APPLICATION RESPONSE

Comments following submission of planning application HGY/2023/1208 to upgrade of a current make shift BMX trail into permanent trail for children of all ages:

The land adjacent to 1 Shepherds Hill, London, N6 5QJ

Shepherds Hill BMX Trail - Application Comments

7.2 Site photos (date-stamped) showing gradual enlargement of ground work starting from 2021:

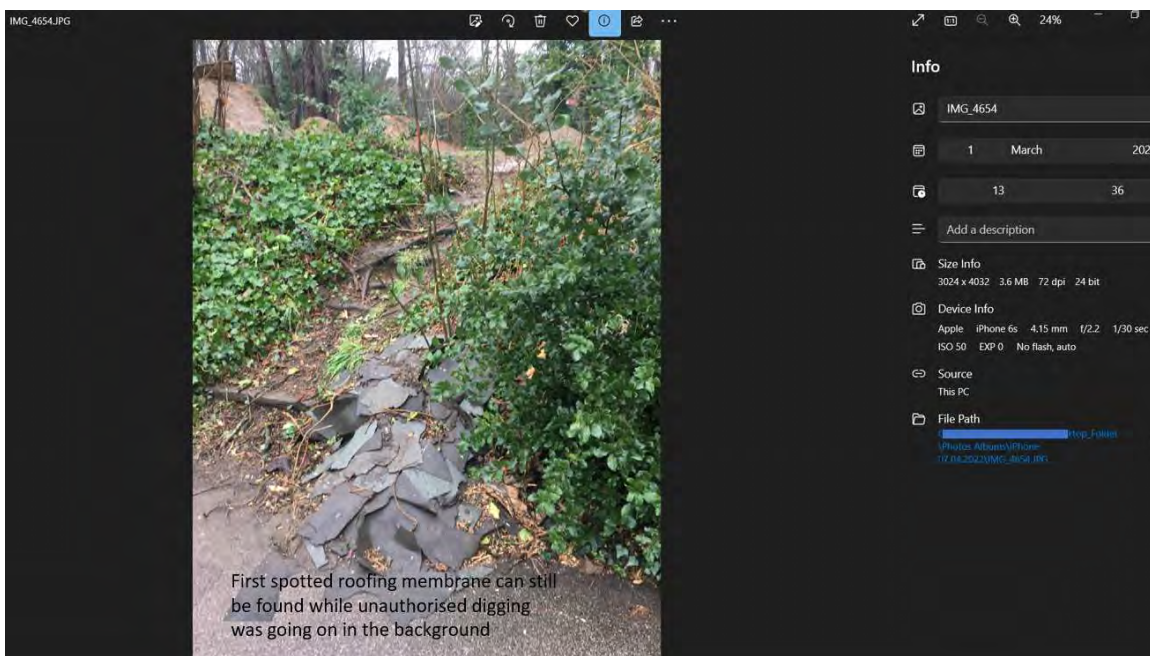
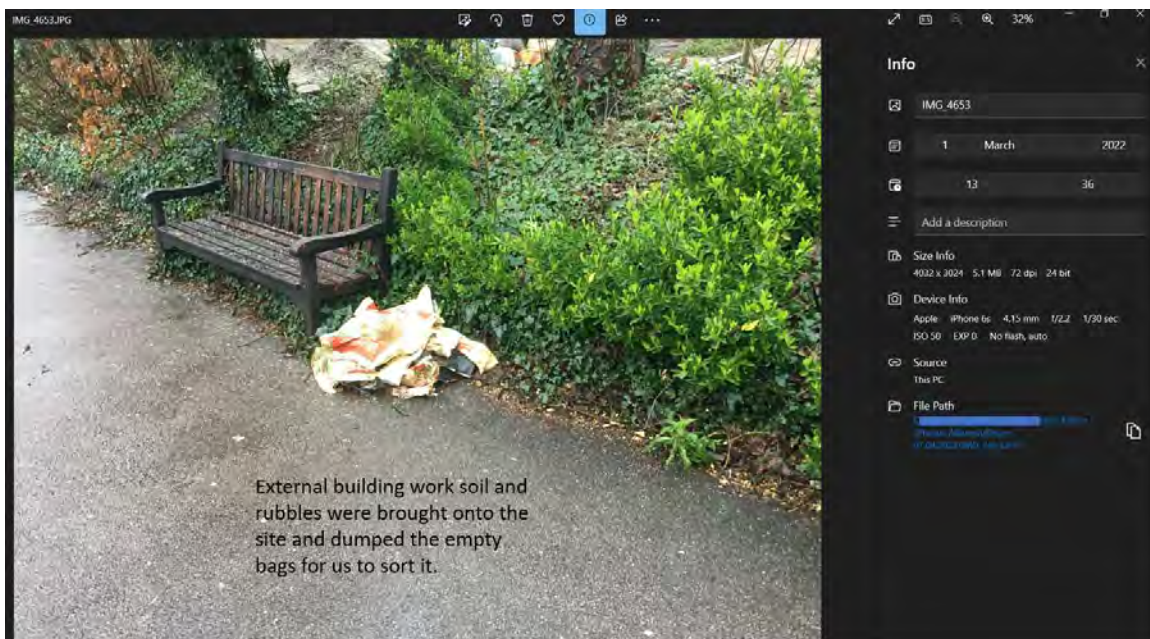
The application states that there has been a 'makeshift' BMX track on the site for a number of years. This statement is very misleading as there has never been a BMX 'track' on the site other than a few built up mounds closer to metal fence that separates the London Underground in 2012 following the Summer Olympics that year. Apart from felling of eight diseased trees by Haringey in Feb 2022, the site has been illegally cleared over the last three years without due regards to neighbouring properties.

This can be verified on Google Streetview. Attached photos taken over recent years show that this site has never been used as an informal bike park. A few mounds of mud would not constitute as an informal bike park. The random Google Streetview scene from 2009 to 2023 shows no such activities. *(Please refer to photos in Section 7.1)*

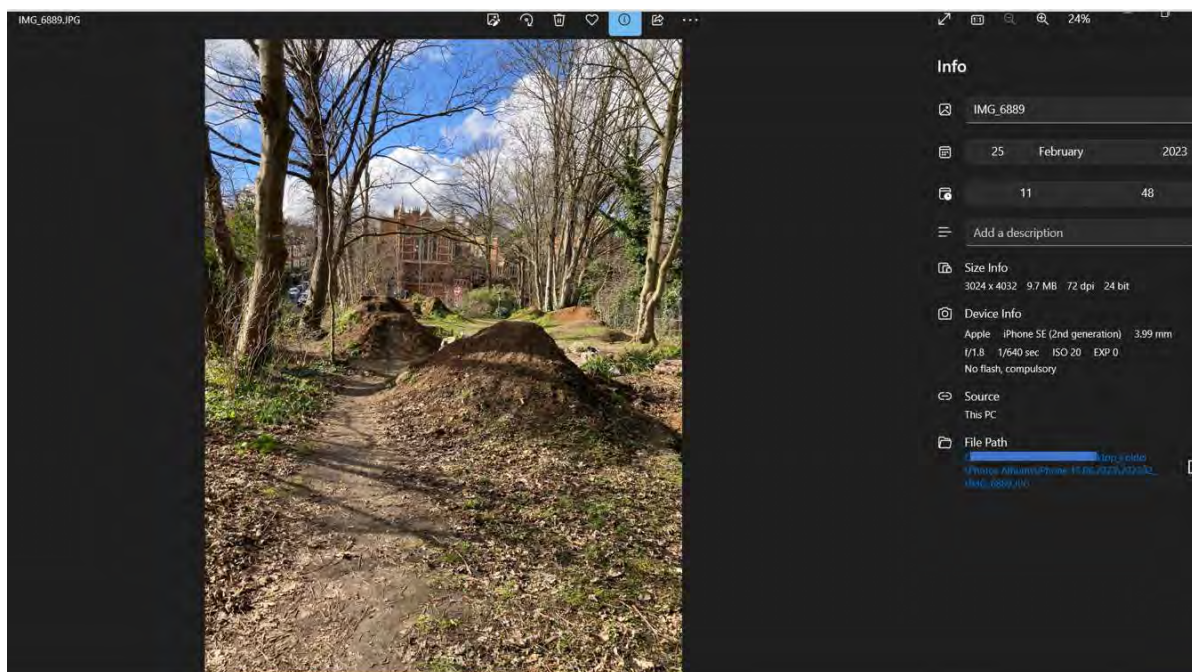
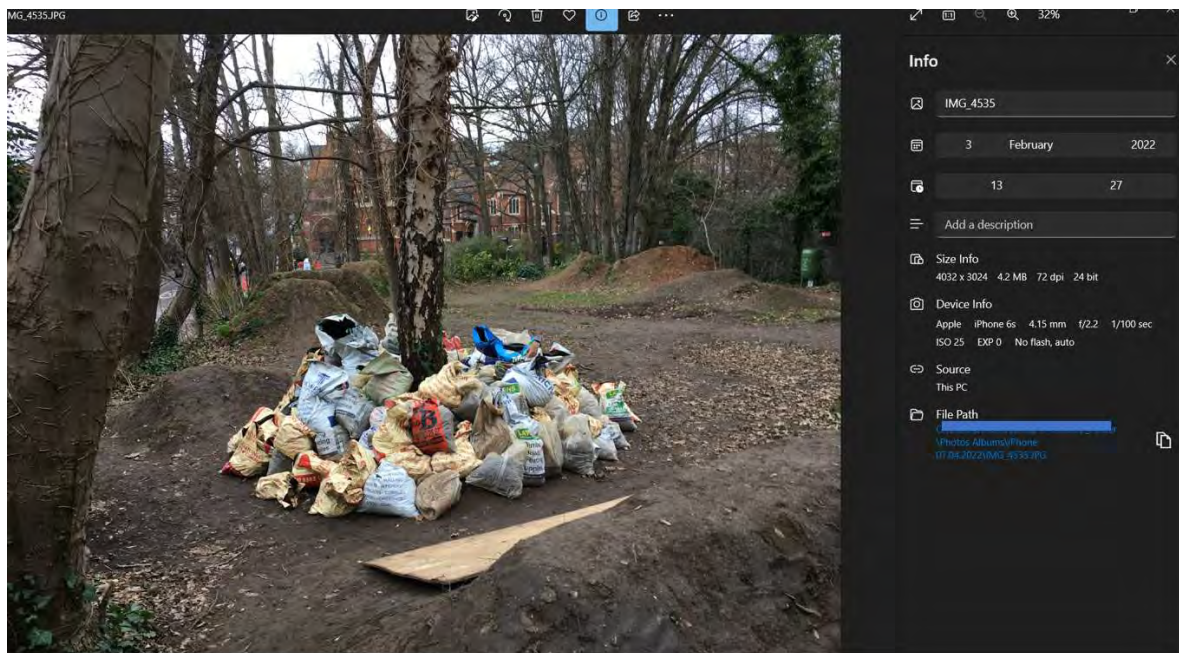
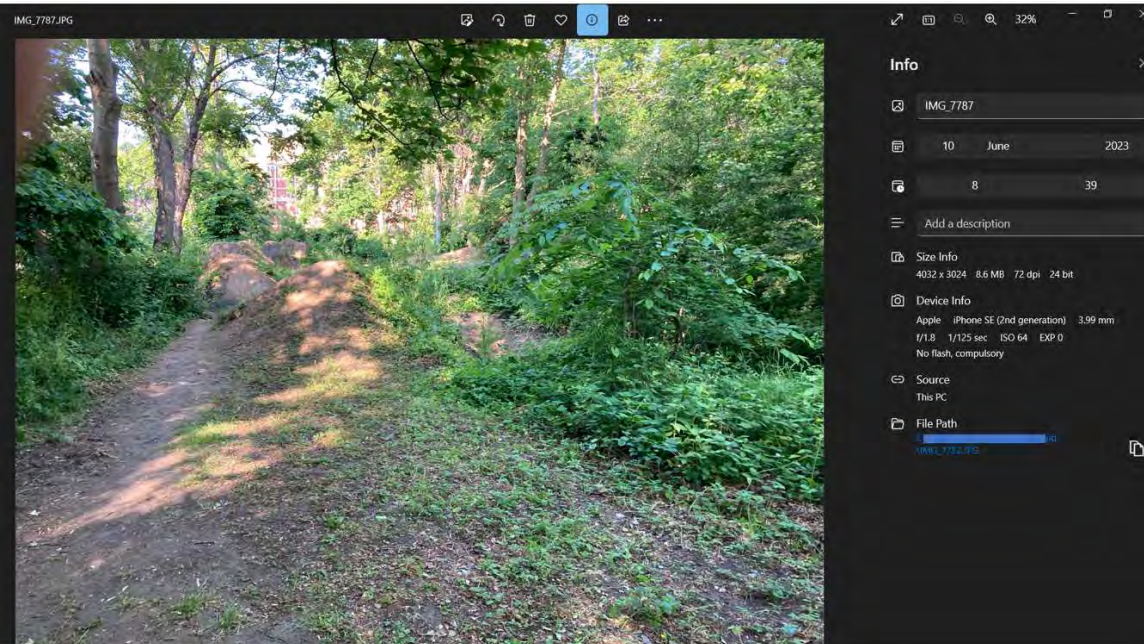
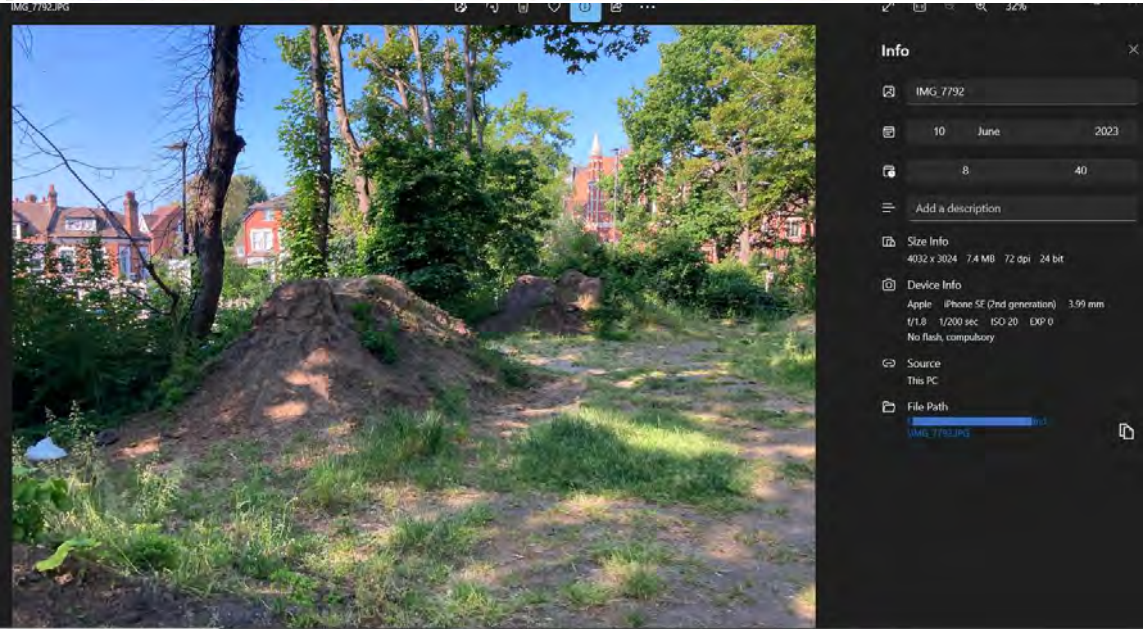
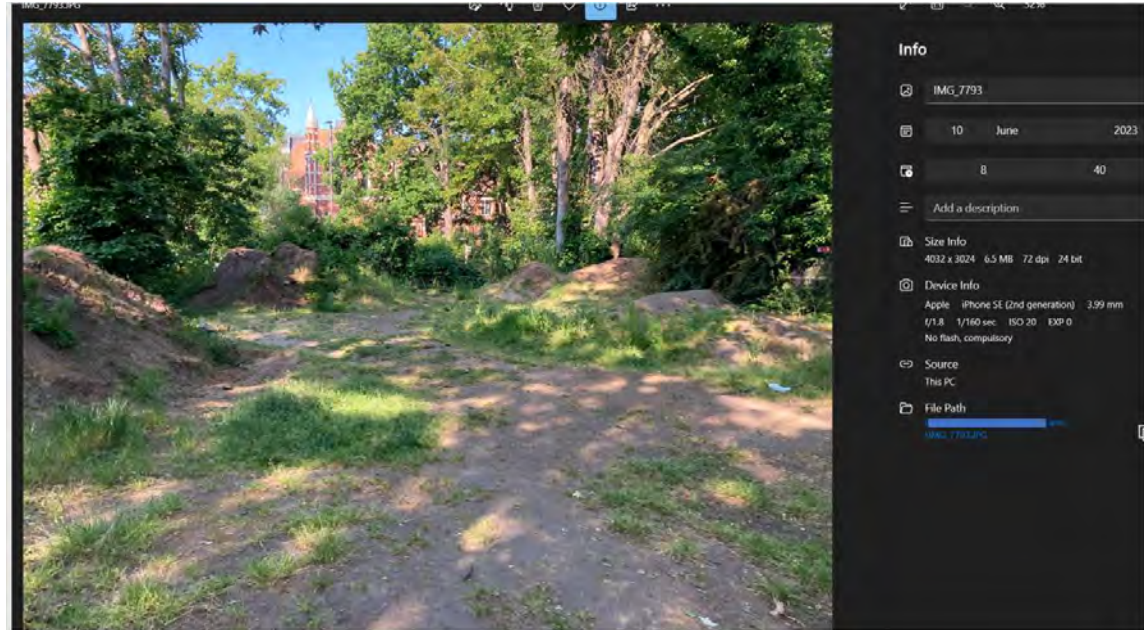
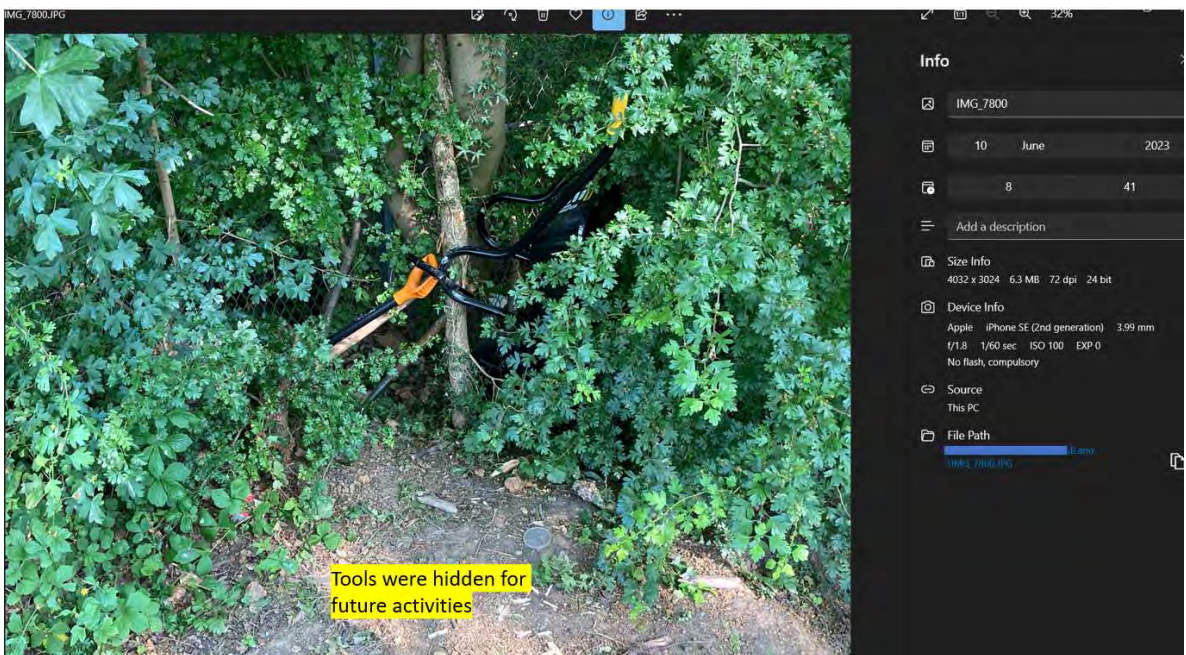
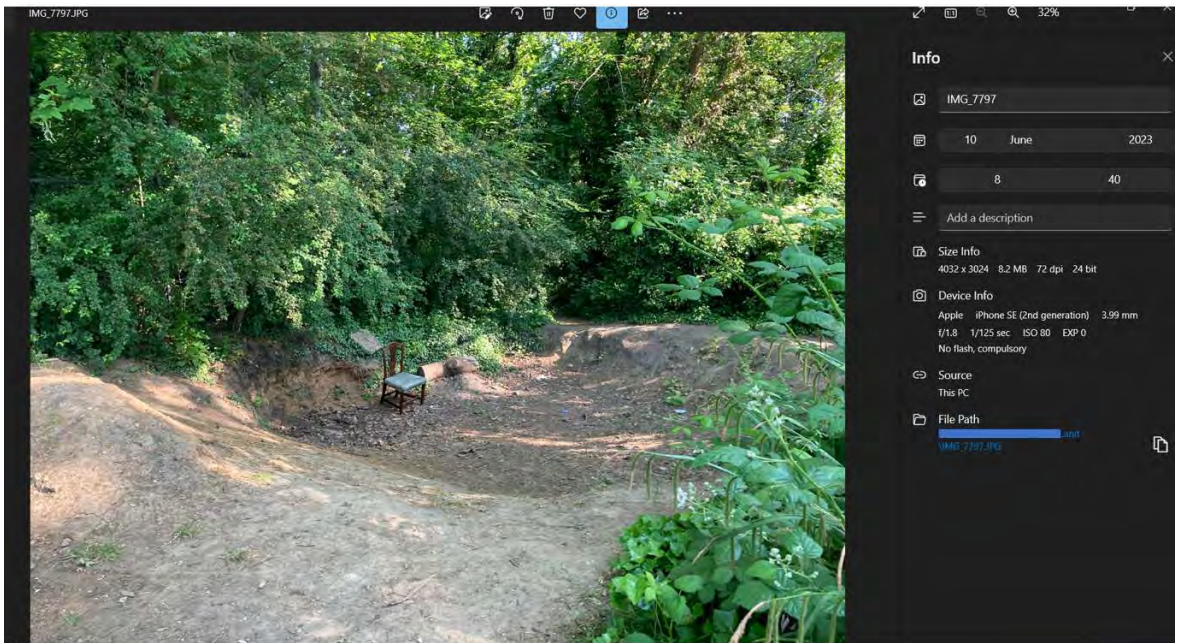
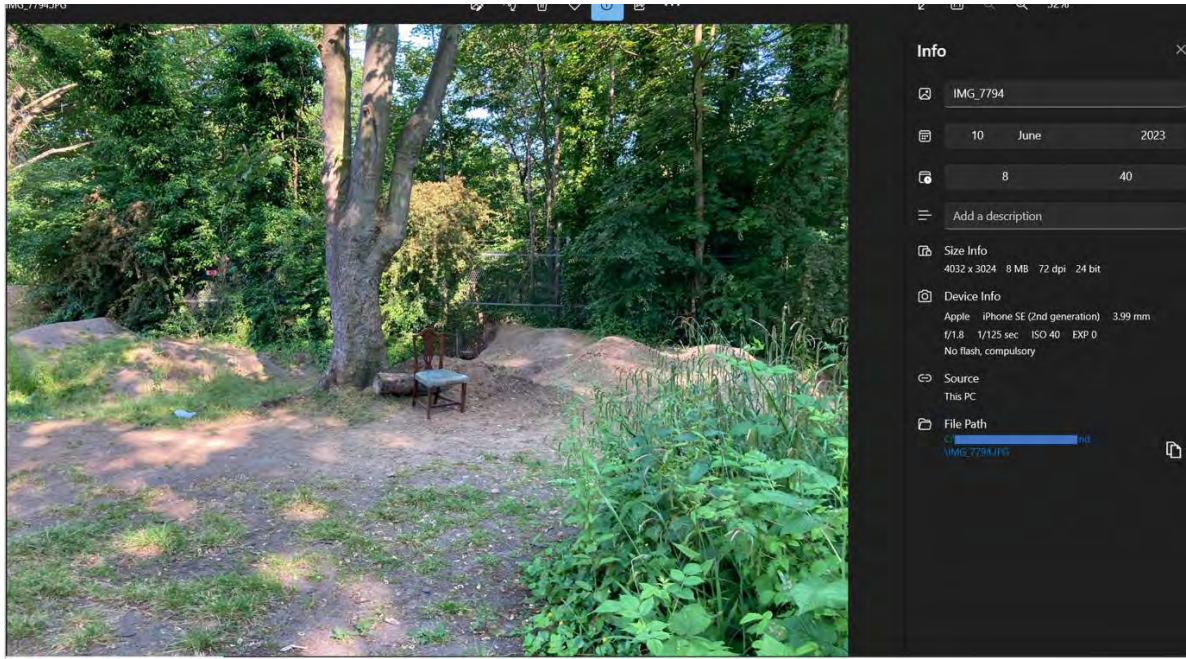
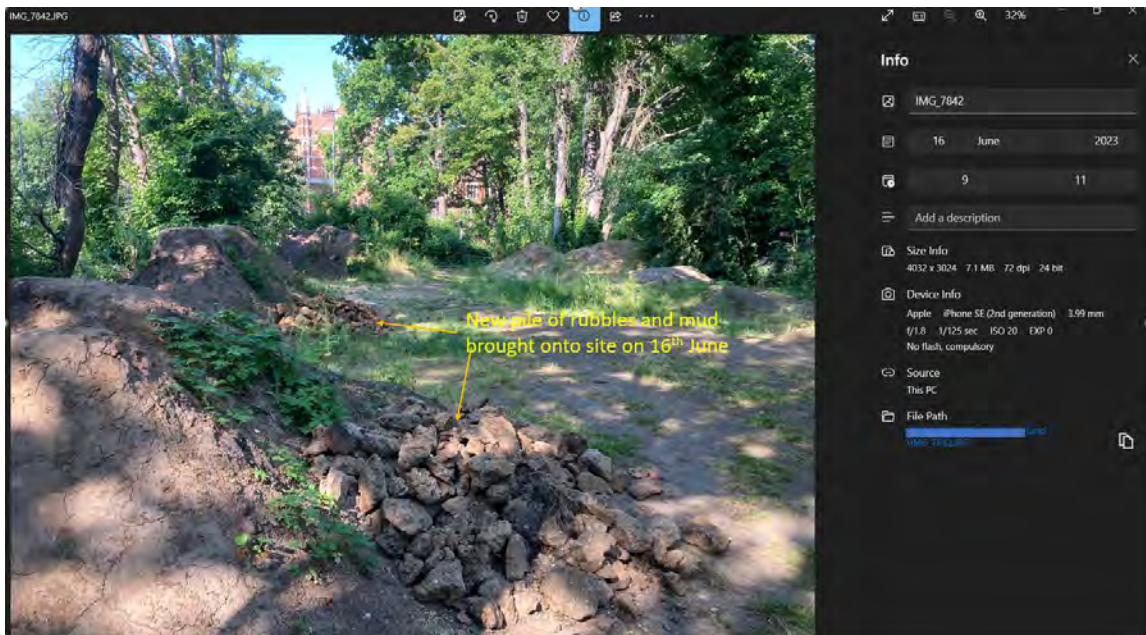
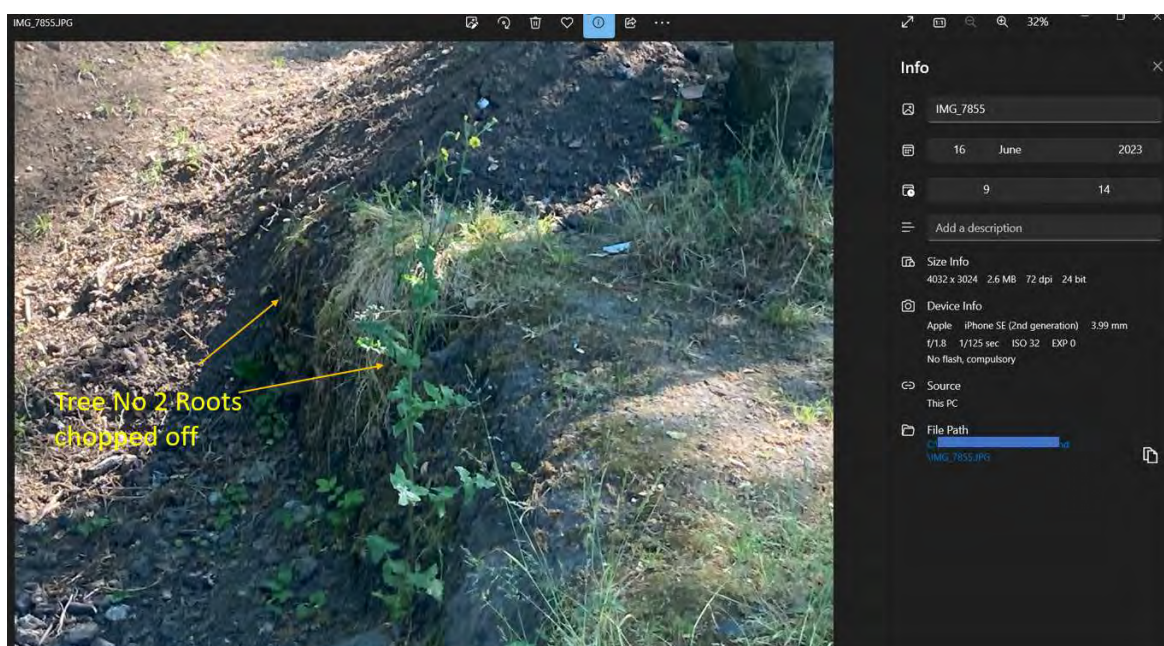
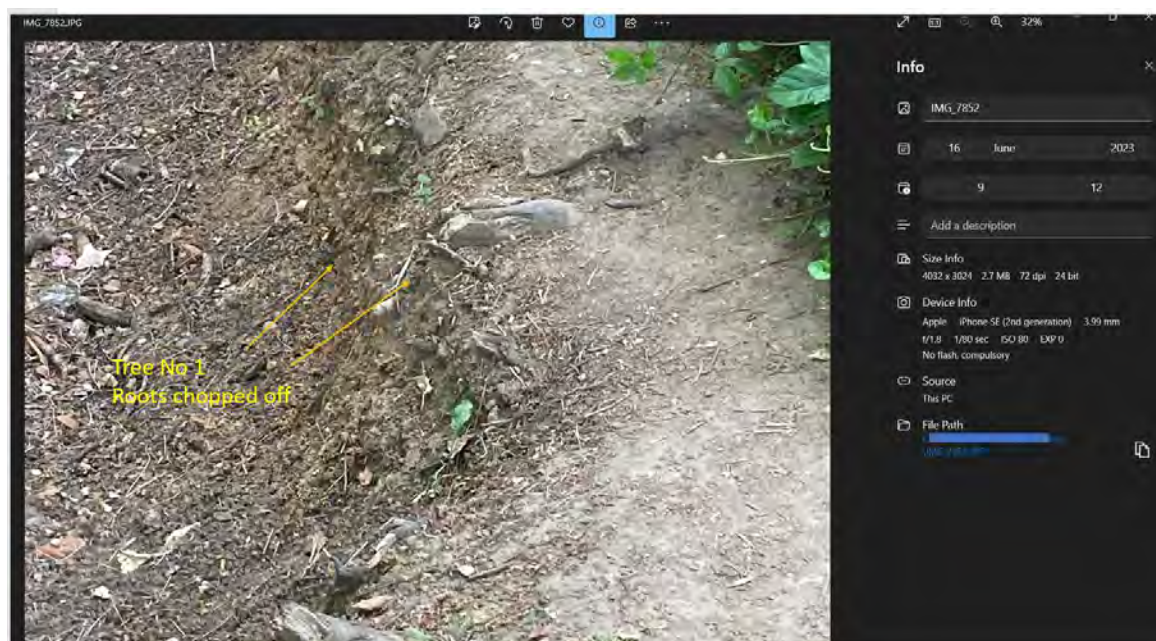
The application further states that it will be a long-term investment with an aim to enrich the public realm whilst preserving local wildlife without going into detail without any supporting evidence. In addition, the application states that existing use of the site as F2 (local community) and the existing and proposed GIA of site will remain unchanged at 564 sqm. without any supporting materials. This is very misleading as there is no enclosure to confirm the boundary other than a few of piles of mud dug up recently. *(Please refer to photos in Section 7.2 and 7.3)*

It is difficult to believe that the process of construction will not result in more damages to trees and/or loss of shrubs and the application should confirm how these will be protected and safeguarded. The application does not take into account that over the last 3 years intense digging activities on the site has damaged tree roots and challenged the health of trees on the site. (Please see photos attached)

There should be a thorough EclA (Ecological Impact Assessment) detailing current atrocities committed to trees on the public land and exposed risk associated with illegal removal and disposal of invasive species. (Please refer to photos in Section 7.2 & 7.3)
